MCPB
Item # 3
Date: 3/16/06**MEMORANDUM**

REVIEW TYPE: Preliminary Plan Review

PROJECT NAME: Montgomery Auto Sales Park

CASE #: 120041010 (1-04101)

PRELIMINARY PLAN OF SUBDIVISION

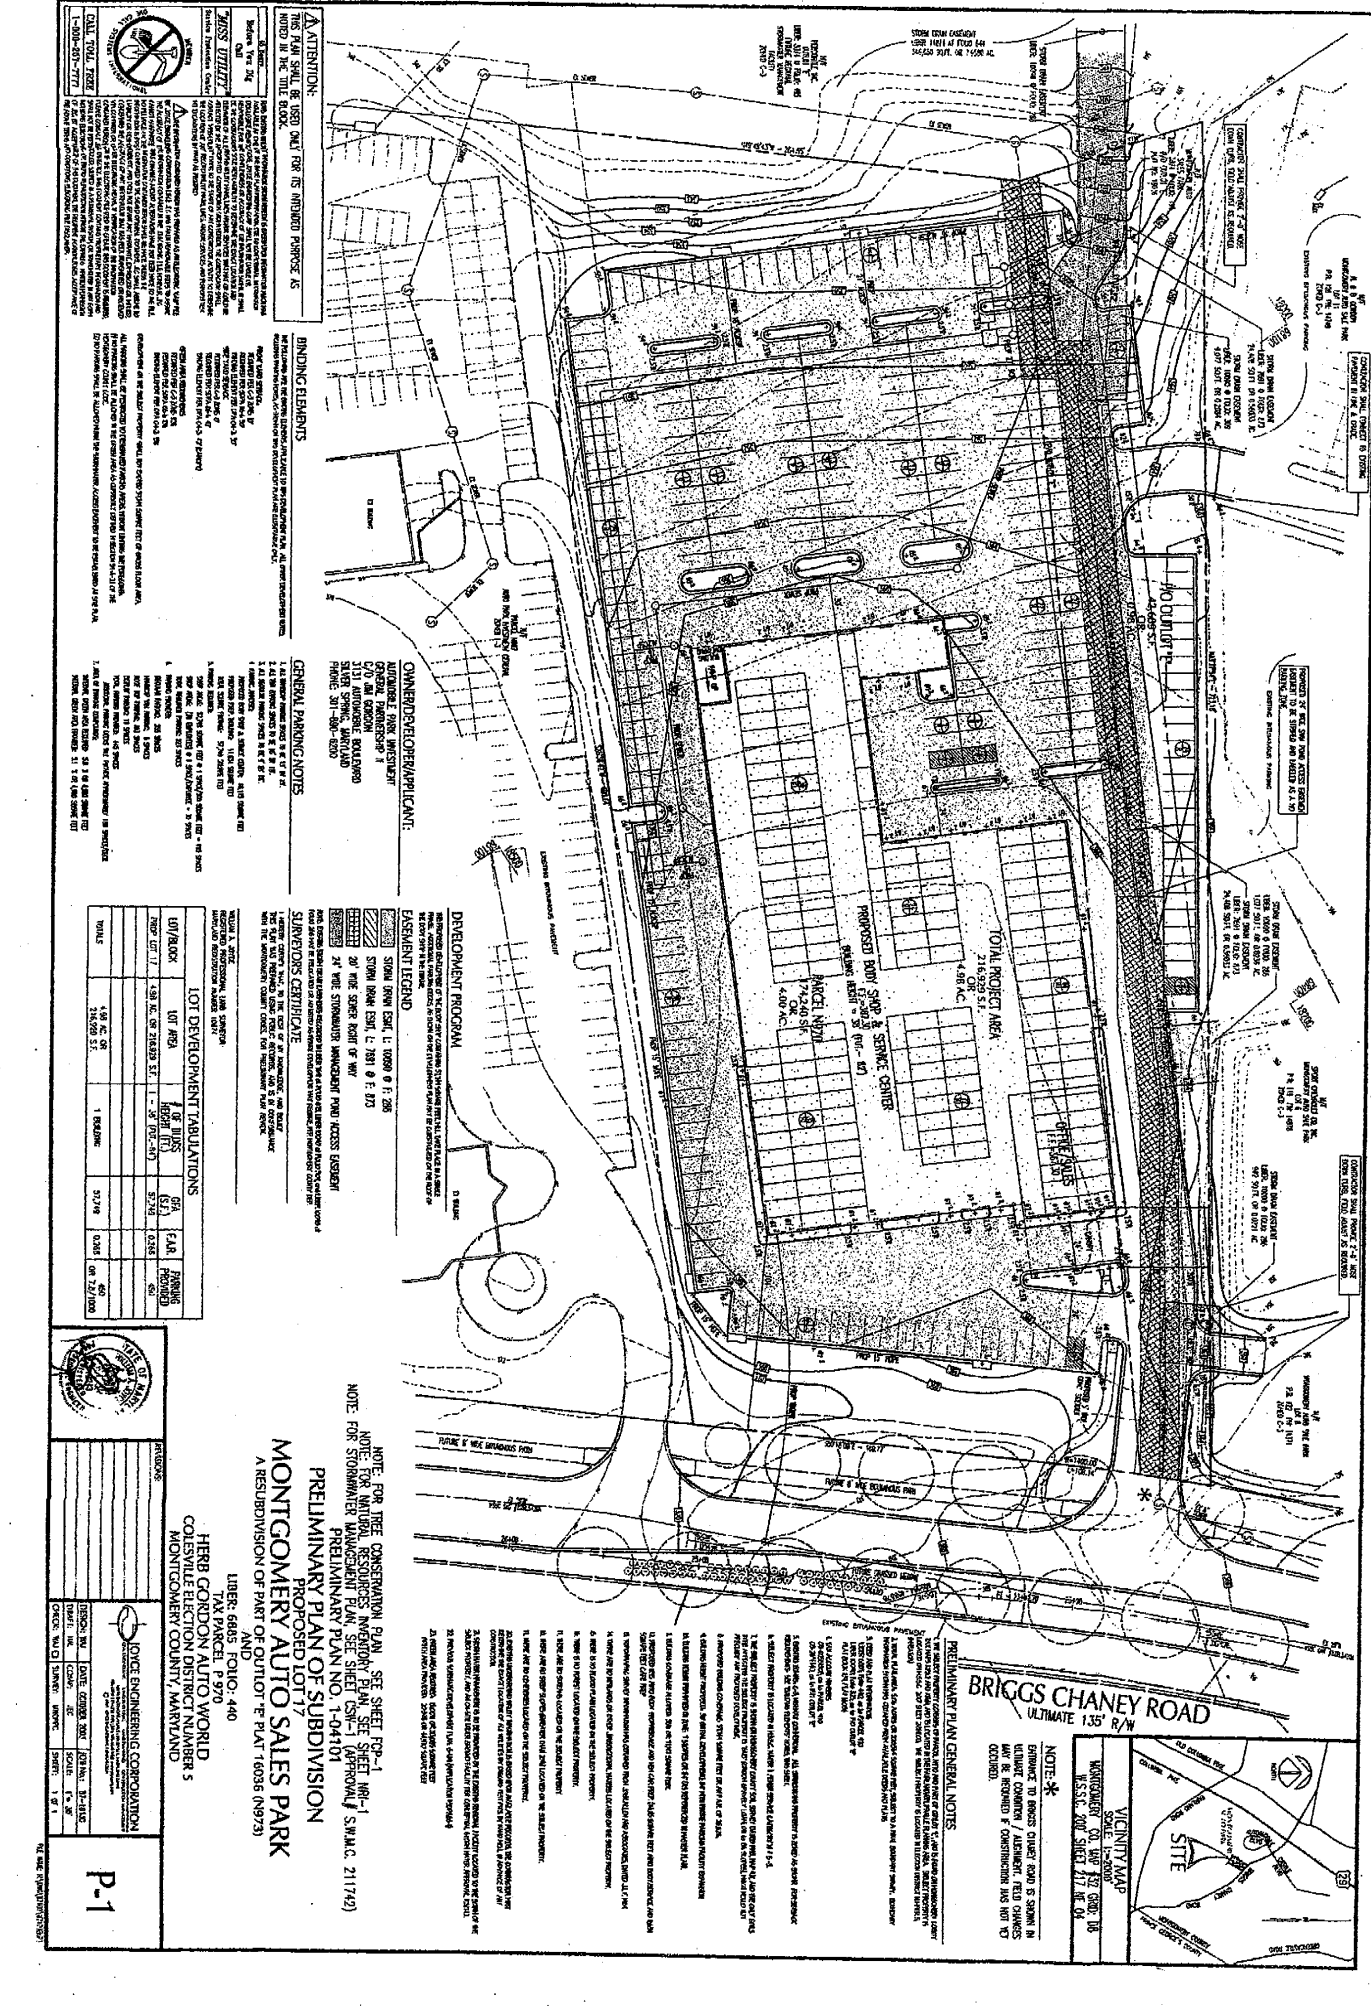
We have completed our review of the preliminary plan printed on July 18, 2005. We recommend approval of the plan subject to the following comments:

1. This plan proposes connections to an existing public storm drain system that is located on the site. Prior to submission of the record plat, the applicant will need to submit and obtain approval of their storm drain capacity and impact study. This study will need to analyze the capacity of the existing downstream public storm drain system and the impact of the post-development ten (10) year storm runoff on same.
2. The sight distances study has been accepted. A copy of the accepted Sight Distances Evaluation certification form is enclosed for your information and reference.
